BLACKWATTLE BAY STATE SIGNIFICANT PRECINCT – Response to Submissions FURTHER HYMIX SUBMISSION

This submission has been prepared by Ethos Urban on behalf of Hymix, who currently own and operate a concrete batching plant located at 45-51 Bank Street, Pyrmont, immediately adjacent the existing Sydney Fish Markets site.

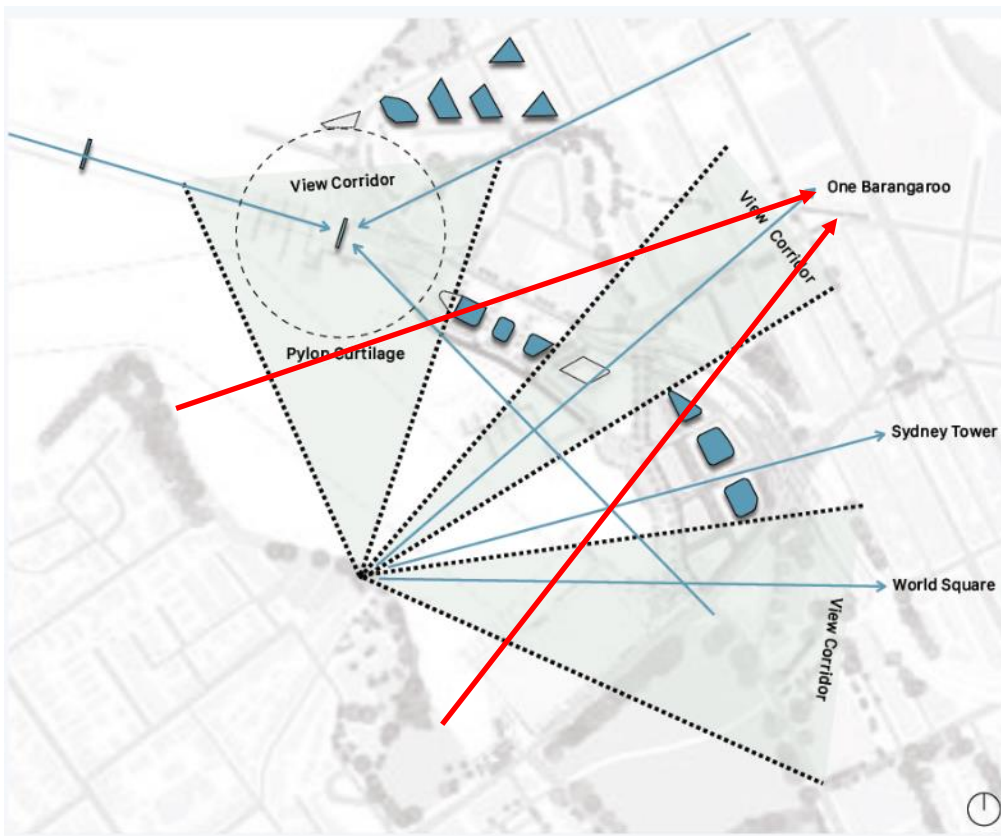
Infrastructure NSW has made substantial reductions in the height of the buildings on the Hymix sites – much more so than changes made to any other building. The buildings on the Hymix site are now substantially lower than all surrounding buildings – especially the built form on Hymix's southern PLO3-2 site. Fundamentally, this removes the feasibility incentive for renewal of the site and undermines the achievement of the urban renewal objectives for the precinct.

The driver for the reduced heights appears to be 3-fold, although in all cases the reasons for reduced building heights appear arbitrary and even self serving, as follows:

The key fundamental driver for height at the site has always been the sun access plane for Wentworth Park. However, in order to justify the need for lower heights on the Hymix site, Infrastructure NSW has arbitrarily selected a part of the new promenade and undertaken solar modelling to show that solar access to that promenade would be enhanced by smaller buildings on the Hymix site. This outcome however is arbitrary and also obvious – solar access across any part of the promenade would be enhanced by reducing the height of any of the buildings across the precinct. Undertaking only one assessment scenario (i.e. reduced heights on the Hymix sites), and showing that it achieves higher solar access to a part of the promenade compared to what was originally proposed, is not a meaningful comparative analysis and it does not demonstrate that it is the best or more appropriate solution. It is a false analysis, and appears to be an exercise in self-justifying the proposed building heights. If

Infrastructure NSW wishes to genuinely investigate solar access to the promenade, then they should consider the benefits that would be achieved by reducing building heights of every building throughout the precinct, across the entirety of the promenade, to understand the comparative benefits.

- **Building Height Diversity**

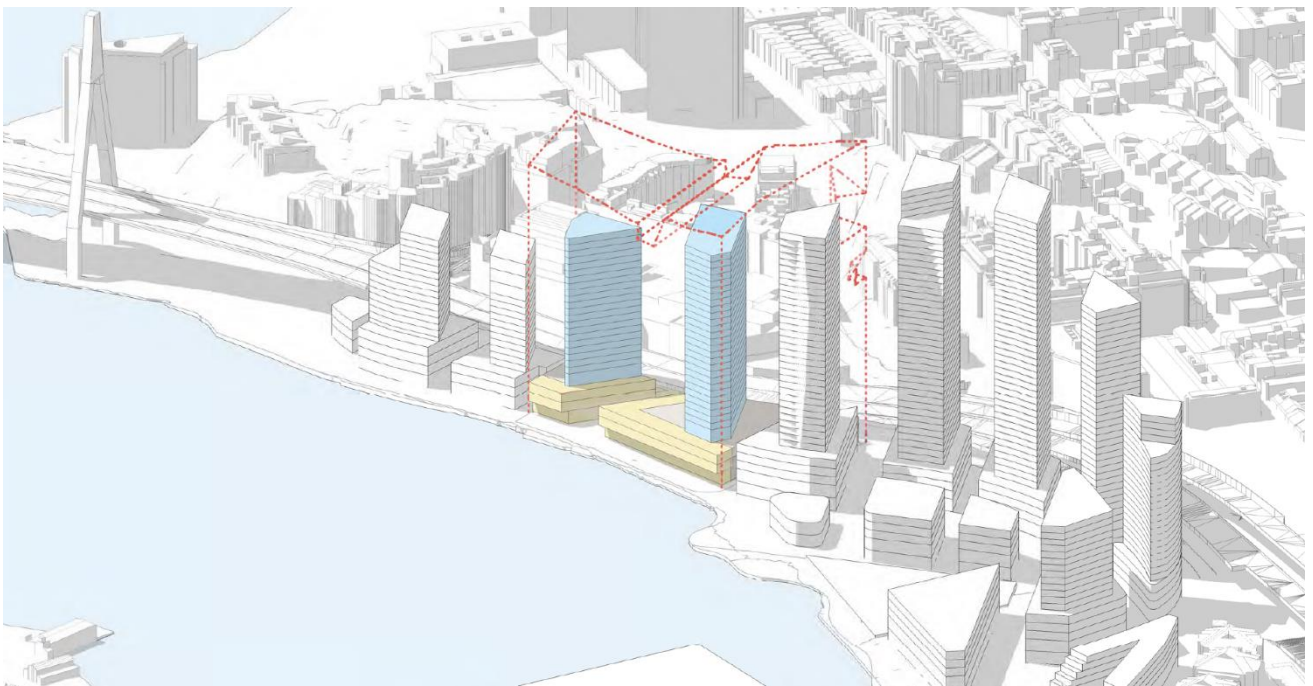
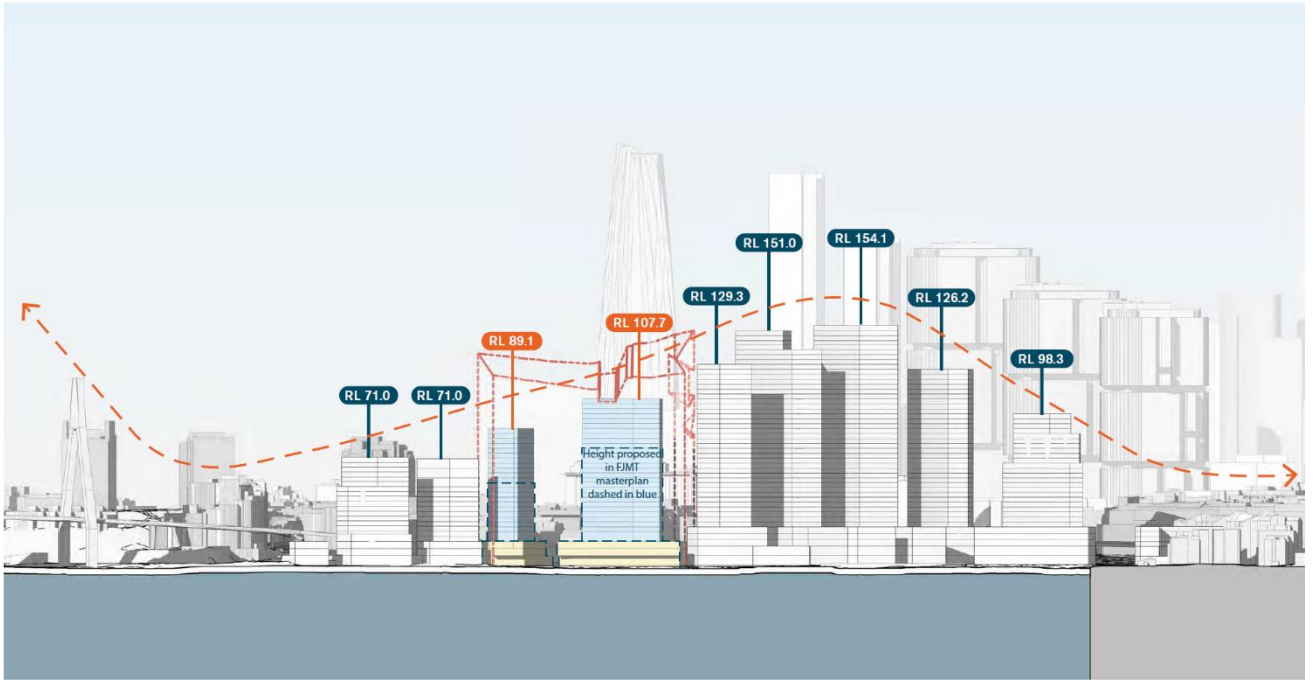
The third justification for the reduced heights on the Hymix site is in response to DPE's request that Infrastructure NSW avoid the appearance of a wall of buildings. Infrastructure NSW has therefore proposed an arbitrary "wavy" shape to justify have short buildings in between 2 tower clusters. The same effect could have been achieved by reducing building heights on the other PLOs or on the northern buildings in the former fish market site. An alternative arrangement that similarly achieves the DPE recommendation is shown in the image below. Again, this 'wave' is self-serving and has no basis in any analytical or beneficial urban design outcome.
